APPLICATION NO.	FILING DATE	FIRST NAMED INVENTOR	ATTORNEY DOCKET NO.	CONFIRMATION NO.
10/559,772	12/07/2005	Sergio Santini	5002-1083	5939
466 7590 04/14/2009 YOUNG & THOMPSON 209 Madison Street Suite 500 ALEXANDRIA, VA 22314			EXAMINER GUMBS, KEEGAN ROSS	
			ART UNIT 4128	PAPER NUMBER
			MAIL DATE 04/14/2009	DELIVERY MODE PAPER

Office Action Summary

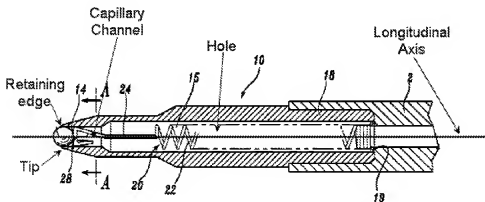
Regarding claim 1, Kim discloses a ball point pen (10) comprising a reservoir (2) communicating with a hole (15, see the annotated figure below) connected to a capillary channel (15, seen the annotated figure below) of a tip (see the annotated figure below)

which is provided with a cavity (16) which seats the ball (30) for writing, the ball being kept pressed against a retaining edge (see the annotated figure below) of the cavity as a result of the thrust of a compression-resilient spring (20) terminating in a straight portion (24 and 28) which is aligned with the a longitudinal axis of the ball-point pen (see the annotated figure below) and a free end of the spring is in contact with the ball (see Figure 8), characterized in that the capillary channel has means (14) which, coming into contact with the straight portion of the spring, prevent it from becoming inclined with respect to the longitudinal axis of the ball-point pen (see Figure 9).

(Member (14) prevents the straight portion of the spring from being inclined; see Figures 8 and 9.)
